This form has been developed to document changes to the NorthMet Project (Project) and/or Project SDEIS Water Modeling resulting from the water modeling process. The forms will be used during the water modeling process. At the end of the process, the Project Description, Data Packages and Management Plans will all be updated to reflect the content of all forms submitted during the process.

Change Type:

Project Refinement

Figure 1 Range in average annual percent of Project discharges to the tributaries that was transferred from Colby Lake

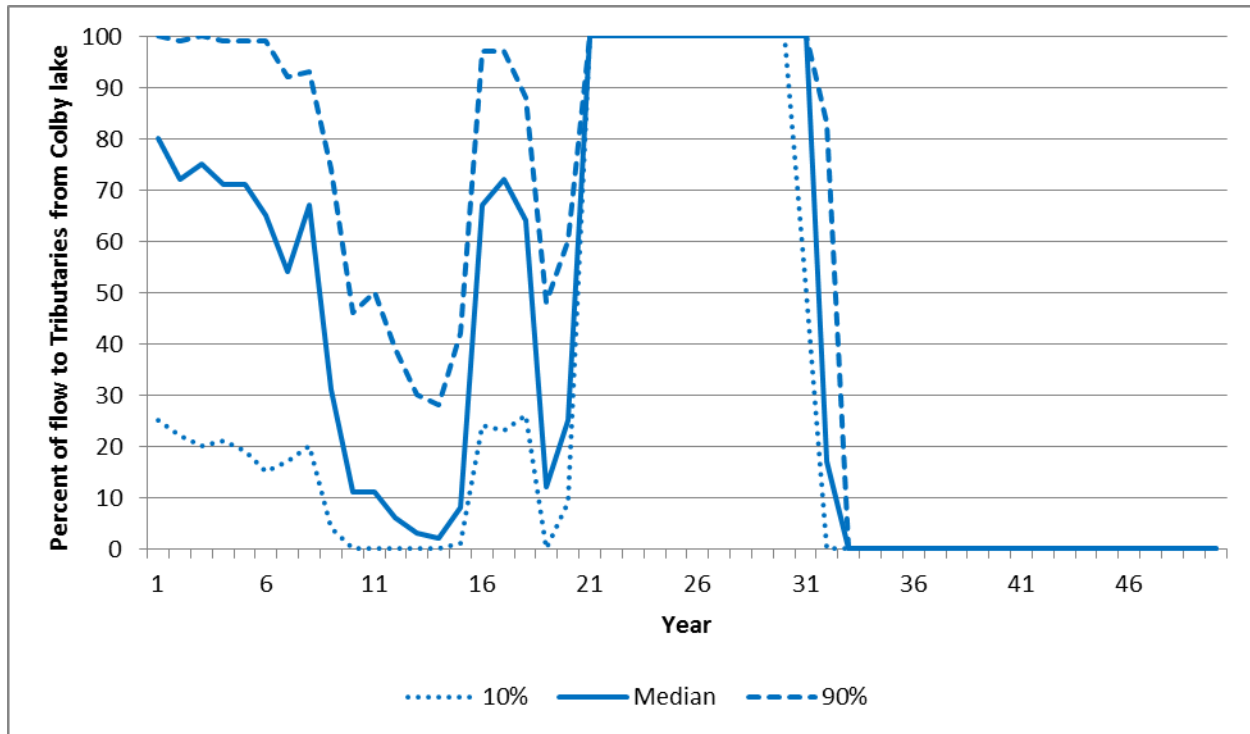
Figure 1 shows the percent of flow discharged to the tributaries estimated to be required from Colby Lake for stream augmentation; the percent from the WWTP would therefore be 100% minus the percent shown in Figure 1.

The amount of water needed for augmentation from Colby Lake is expected to vary significantly through time (Figure 1). A few periods of interest are:

- Earlier years when seepage from the FTB is estimated to be near existing conditions and flow from the Mine Site is estimated to be relatively low. Most seepage will be returned to the FTB pond and less water will be treated by the WWTP and discharged. During this period, the demand from Colby Lake is estimated to be high.

- Years 10 to 15 when flow from the Mine Site is estimated to have increased substantially and seepage rates from the Tailings Basin are estimated to have increased. More water must be treated and discharged by the WWTP reducing the demand for Colby Lake water.

- Years 15 to 18 when water from the Mine Site is estimated to have significantly decreased due to filling the East/Central Pit. Again, more seepage can be returned to the FTB pond, increasing the demand from Colby Lake.

- Years 18 to 20 when it is expected that the pond will be reduced in size to prepare for reclamation. More water will be treated and demand from Colby Lake will be reduced.

- Years 20 to about 32 when all treated and collected water will be sent to either the FTB pond to maintain water levels or to fill the West Pit at the Mine Site. Therefore, the entire flow demand in the tributaries will be met with Colby Lake Water.

- Finally, in Long-Term Closure, the flow that will be captured, treated by the WWTP and discharged will be sufficient to meet the average annual demand of the tributaries and Colby Lake water will no longer be needed for augmentation.
